# MEMO

**Department of Water Resources**

**Subject:** Transfer Nos. 72674 and 74088, in the name of Comore Development

**Figure 1. Contour map of steady state head for modified ESPAM.**

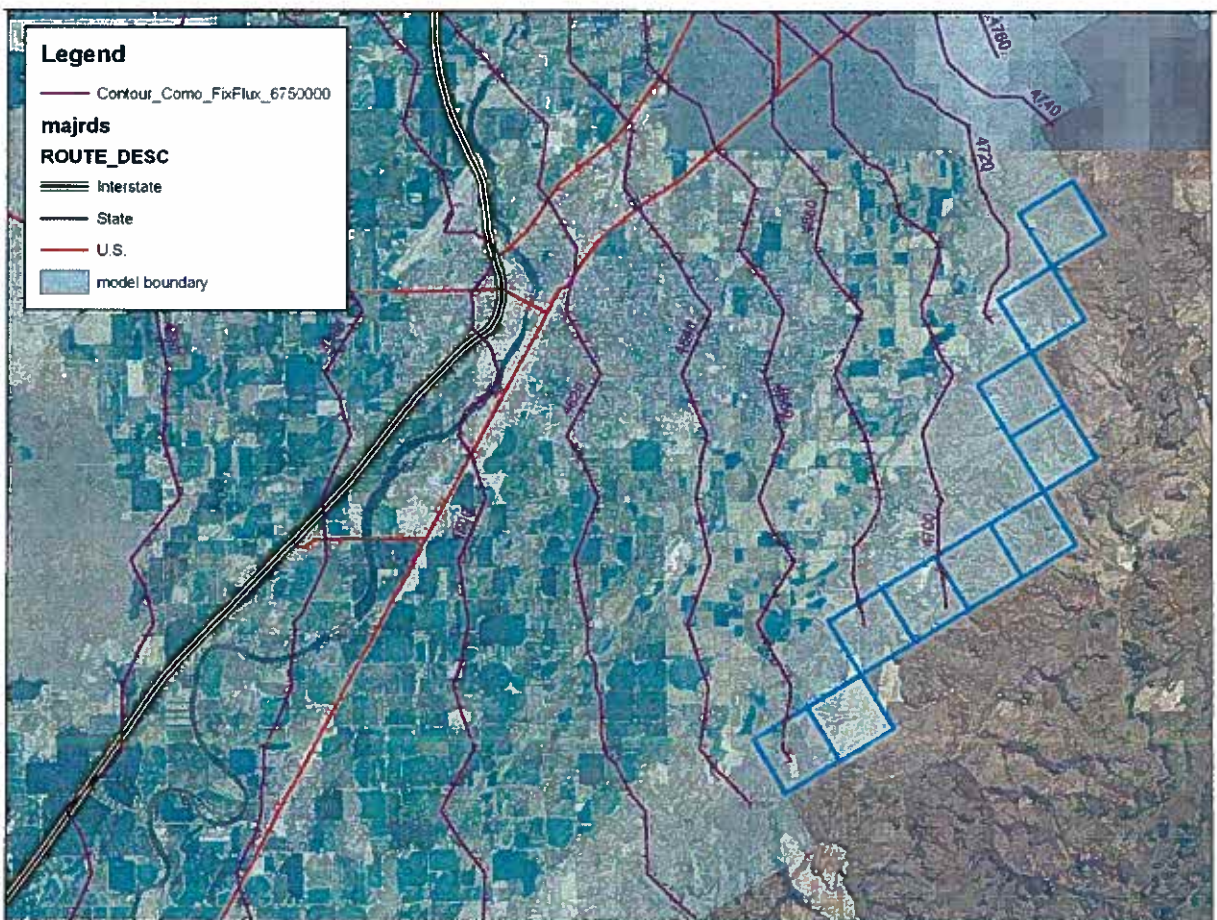
Comore well. They identify the boundary cells on page 35. I used these fluxes in the identified cells to impose a constant flux boundary (vs. the GHB used by Clearwater) east of the Comore well. Table 1 shows the model cells and flux. I ran the modified ESPA model to steady state and saved the results. Figure 1 shows the resulting head distribution in the vicinity of the Comore subdivision.

The above modifications to the ESPAM are intended to counter Clearwater's argument that ESPAM V 1.1 can not be used to evaluate the Comore transfer because the potentiometric lines in ESPAM V 1.1 intersect the boundary near the Comore subdivision at right angles rather than paralleling the boundary as Clearwater presents in Figure 8 of their report.
